**Planning Commission
Work Session
October 28, 2021 – 5:00 p.m.
233 South Main Street, Monroe, Ohio**

Work Session regarding Hyde Park at the Crossings, a proposed residential development at Roden Park Drive and Crossing Boulevard.

I. Administrative Report—Hyde Park at the Crossings Residential Development

RE: Hyde Park at the Crossings
Planning Commission Work Session

PROJECT NUMBER	18036
DRAWN BY	Pete Lindsey
DATE	4-5-18
EXTERIOR ELEVATIONS	
SHEET NUMBER	A-4

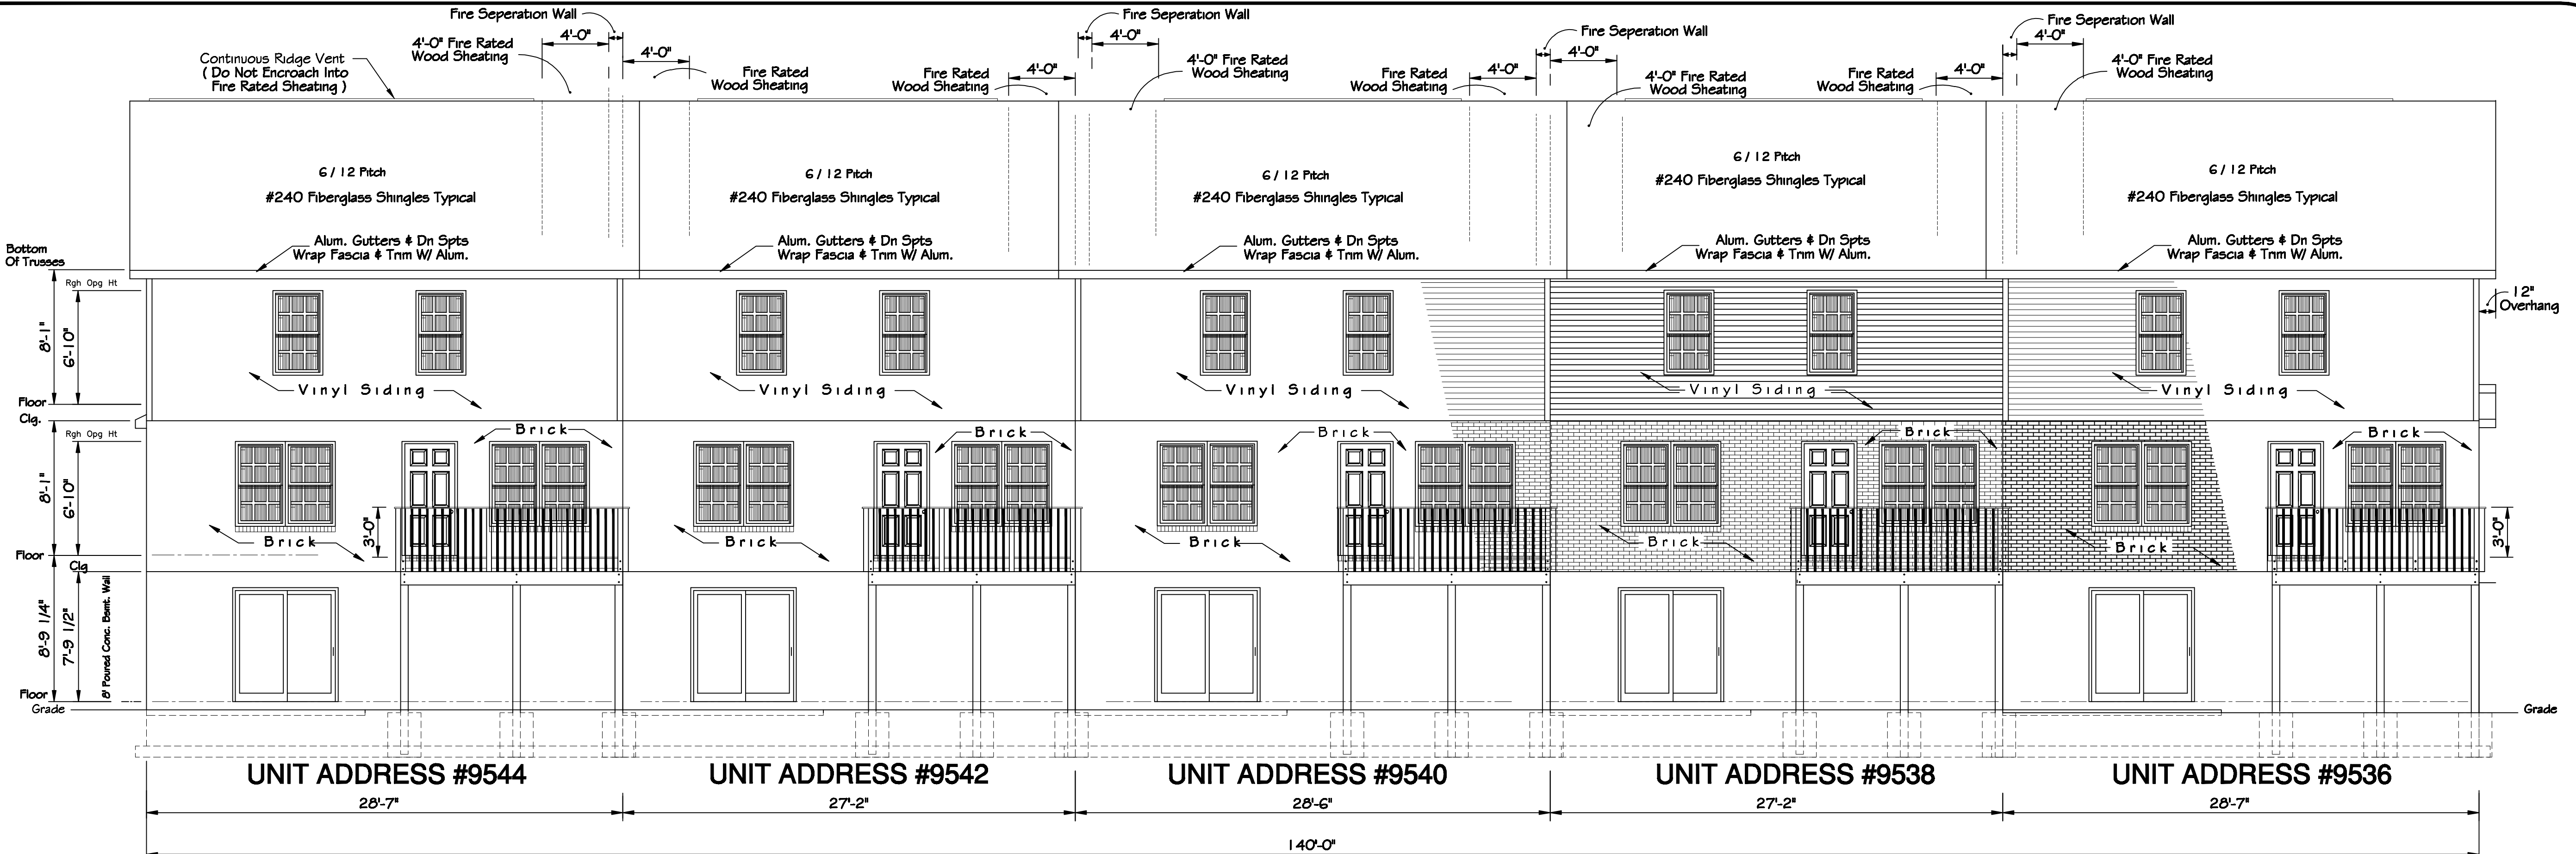
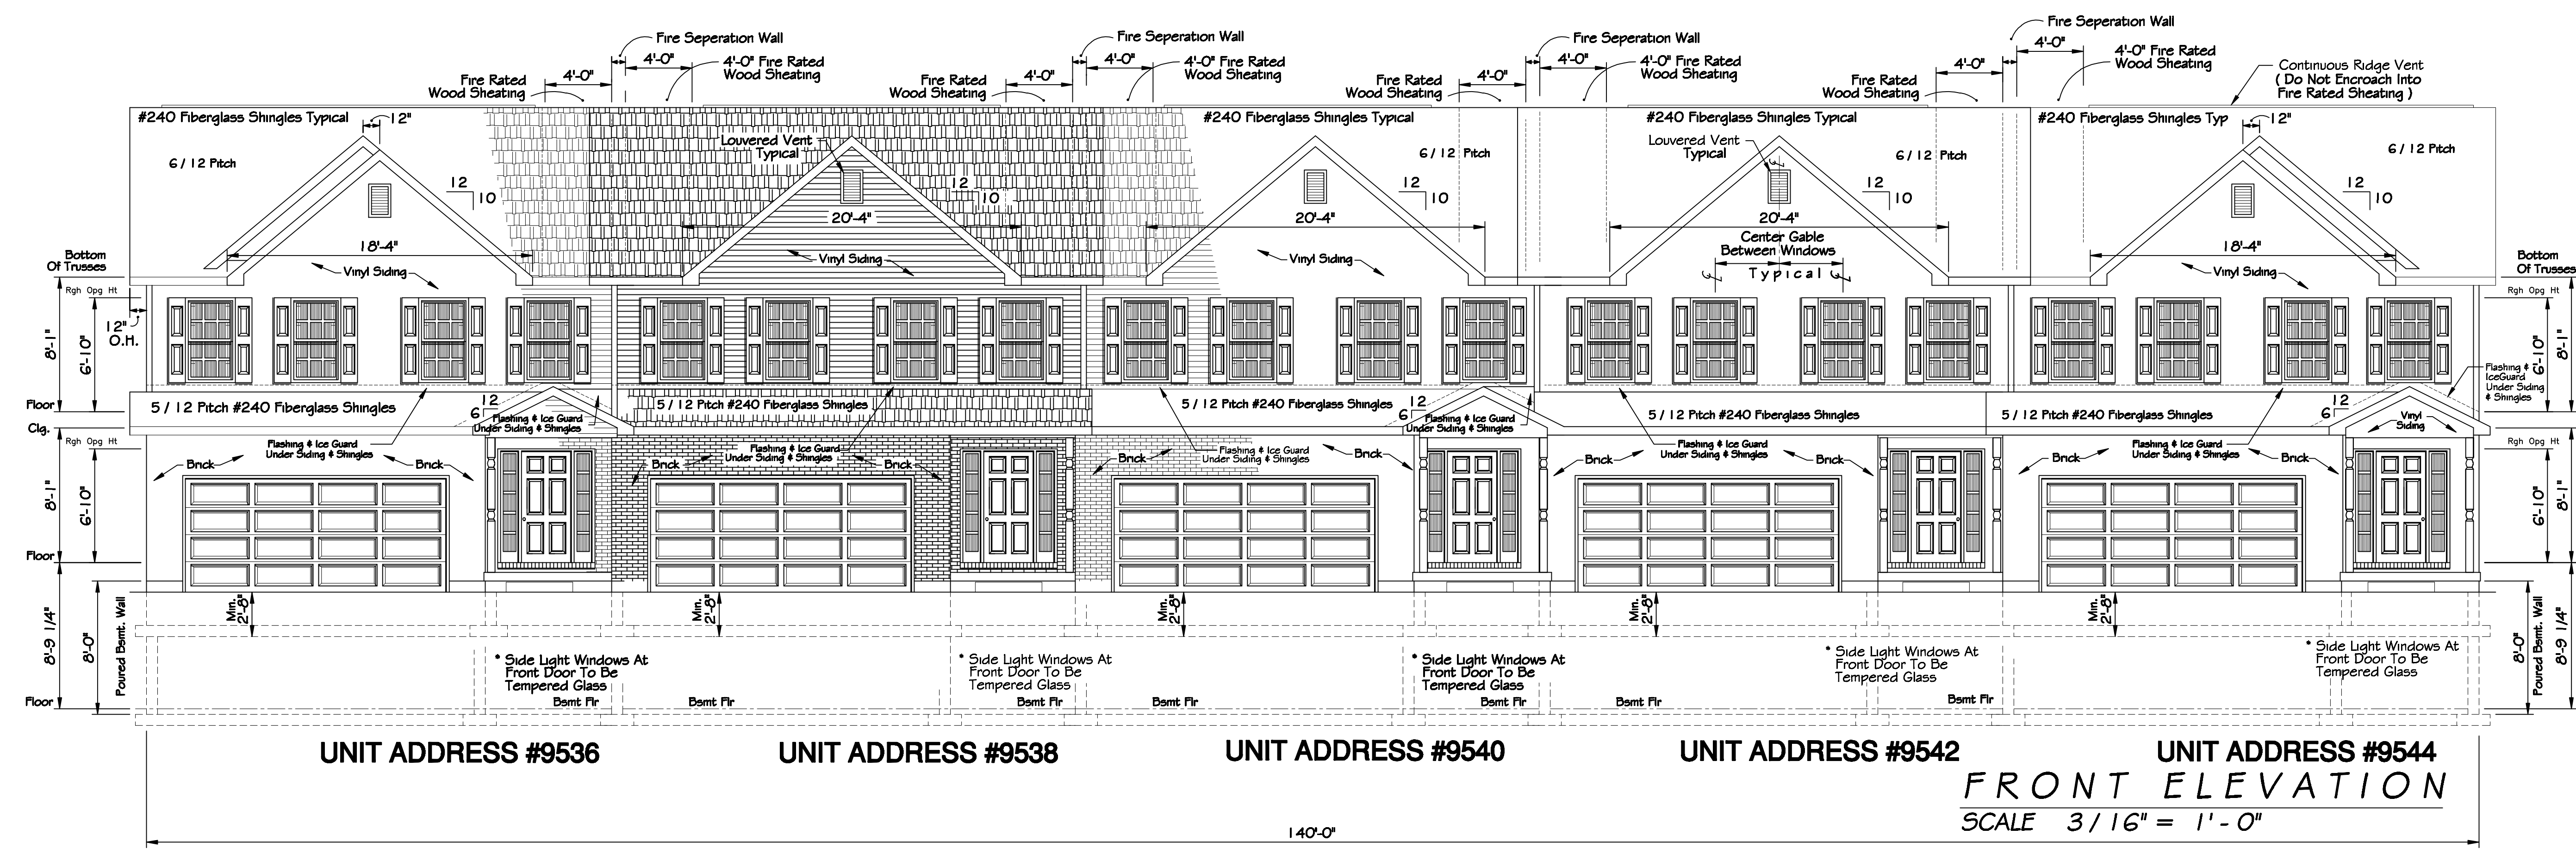
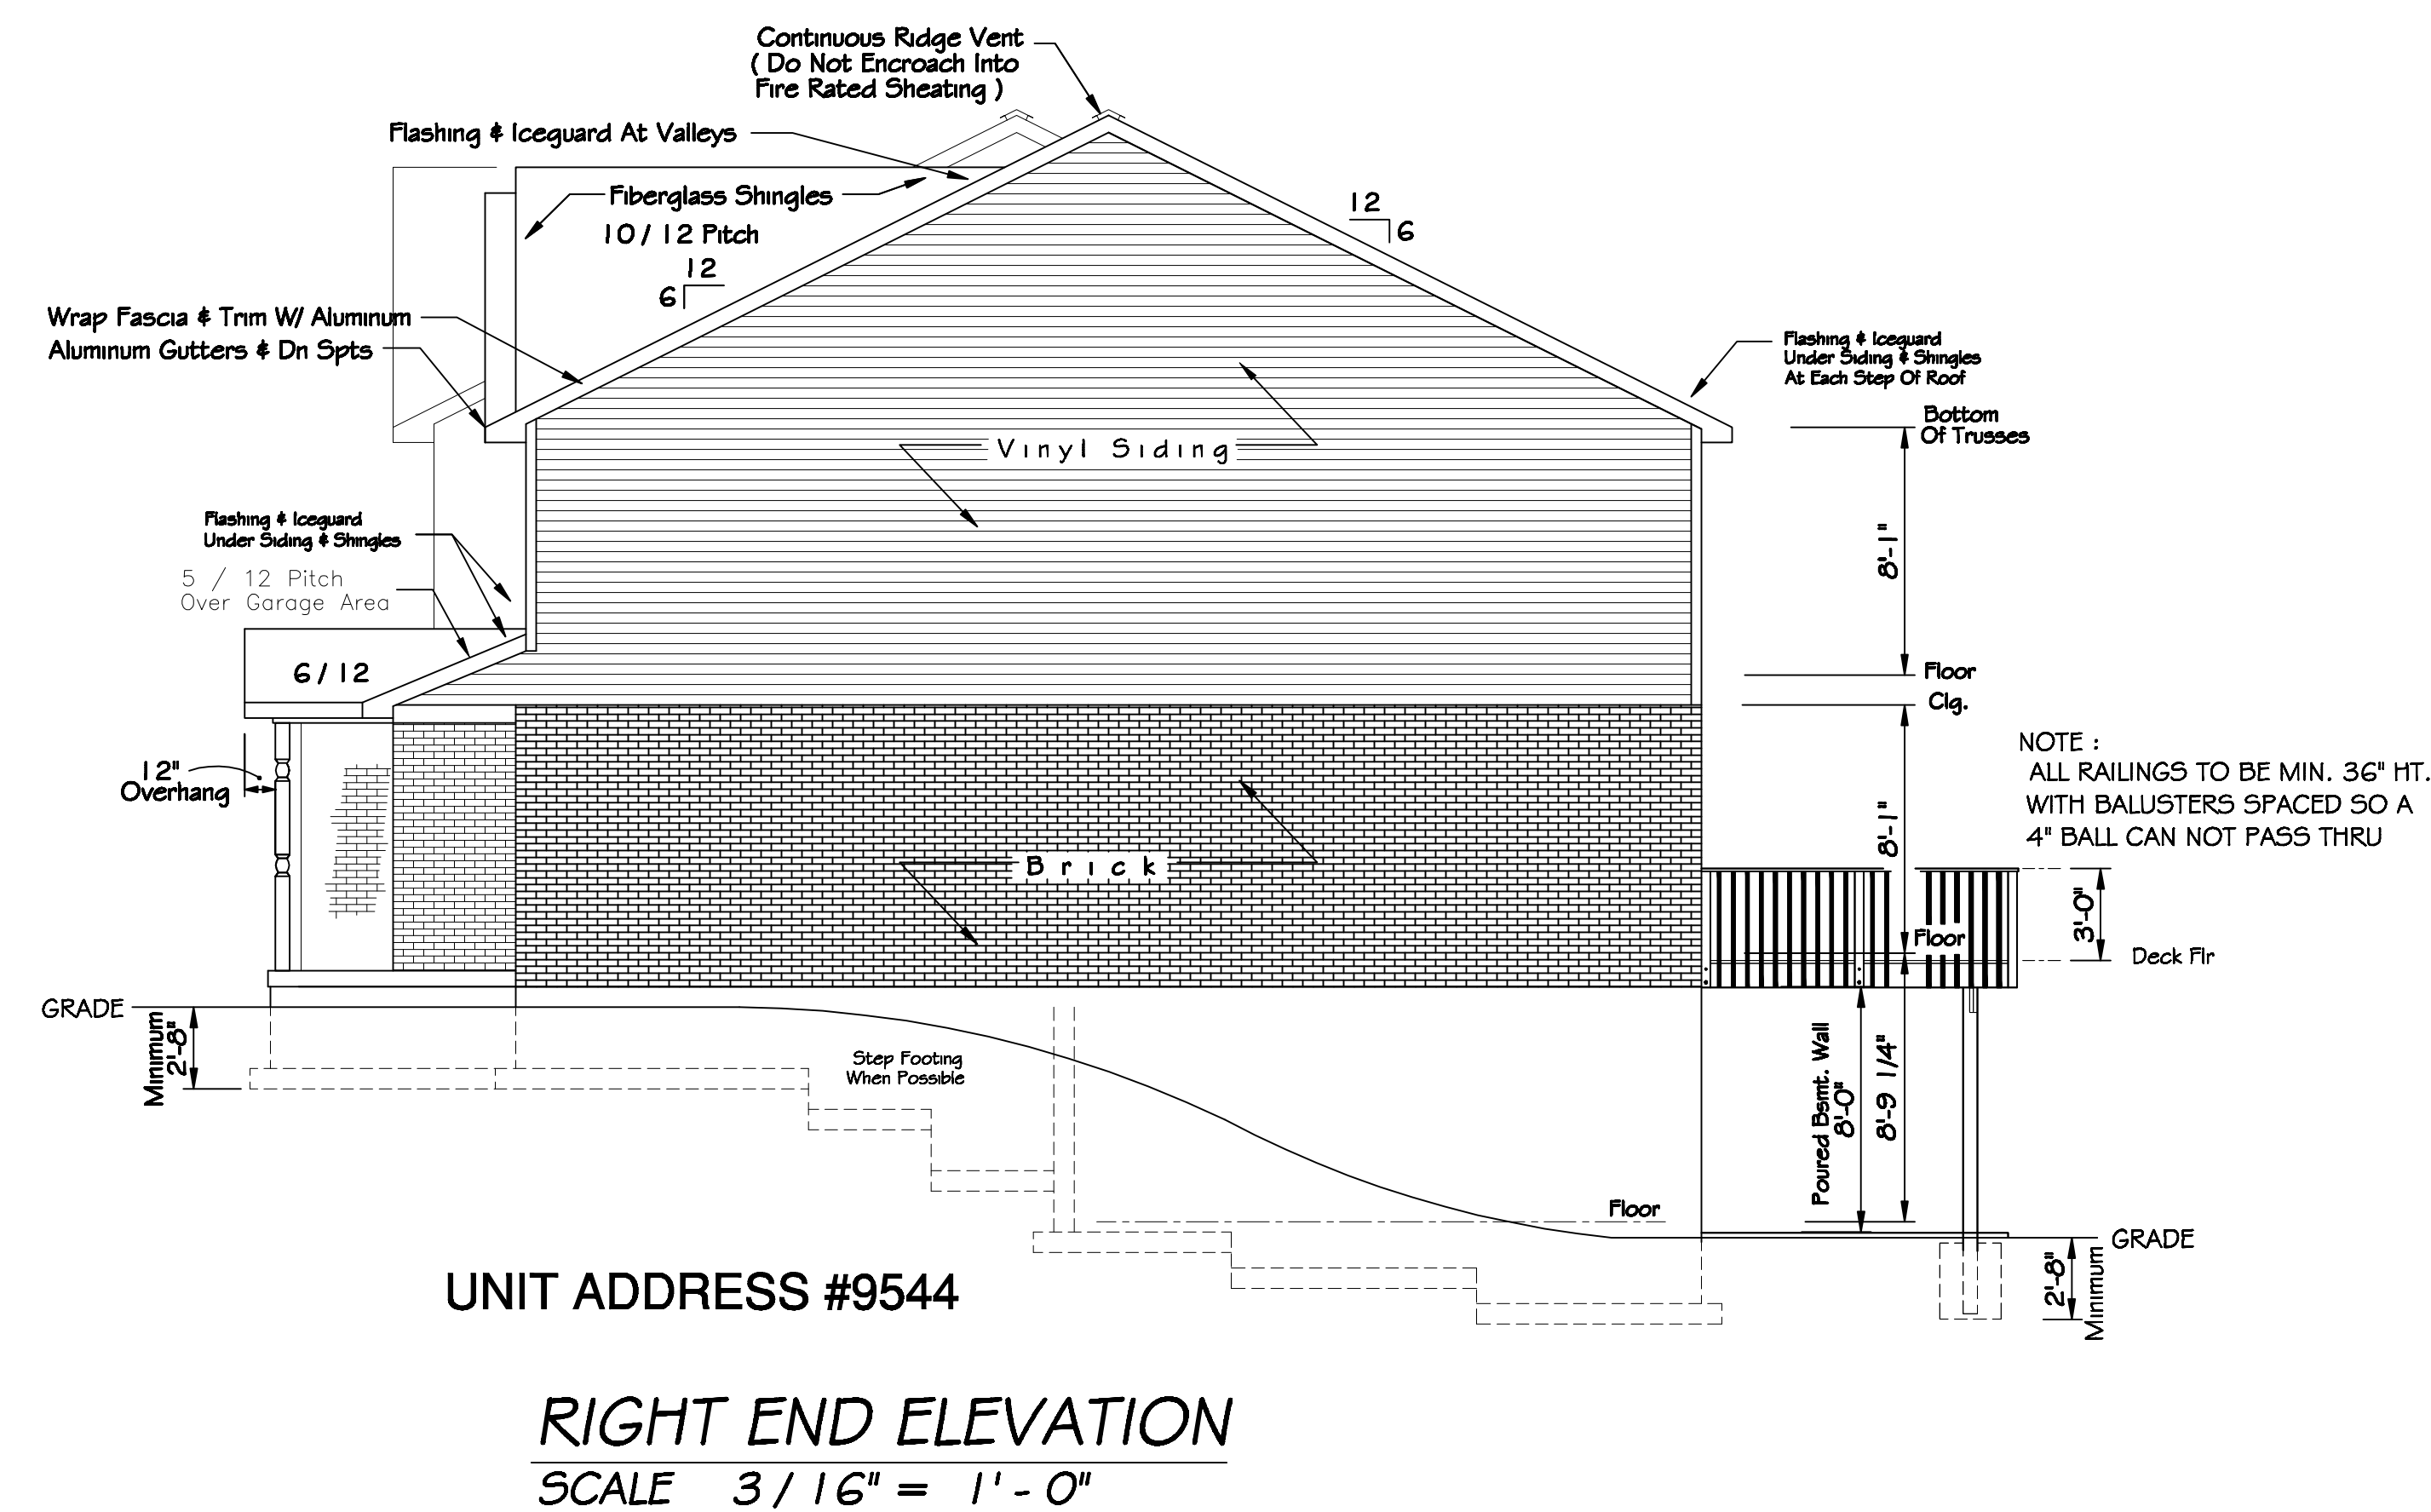
- Based on renderings provided, it appears some of the models have more than 25% siding permitted on the front elevations. The maximum on front elevations is 25%, with 75% required to be brick or stone.

- Front elevations must incorporate variation in mass through methods such as wall offsets 2 feet deep, bay windows, façade color changes, use of pilasters/columns, roofline changes, etc. Based on information provided, it appears wall offsets, façade color changes, columns/pilasters, and roofline changes have been incorporated.

- Side and rear elevations must contain a minimum 50% brick or stone. This requirement has not been met.
- Front and side facades (on buildings located on corner lots) must include a combination of design elements such as dormer windows/cupolas, recessed entrances, covered porches, pillars/posts/pilasters, bay windows, multiple windows with minimum four inch trim, etc. The front elevation does appear to show multiple windows, recessed entrances with covered porches, and pillars/posts, but side elevations do not meet this requirement.

- Vinyl is proposed for this development, which is currently prohibited per code.
